IMPORTANT SAFETY RECALL

NHTSA Number: 26V-246 (School Bus)

NHTSA Number: 26V-245 (Non-School Bus)

SUBJECT: R26AB: All Weather Wiper Blade Loose Nut

Diagram A

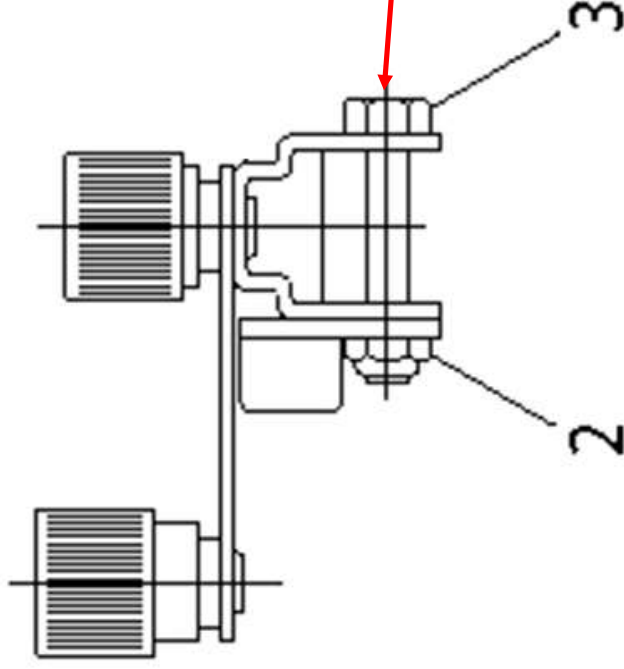
1. Remove and install new saddle nut (2) and bolt (3) as required and set torque to 8-10 ft-lbs. (11-13 Nm)
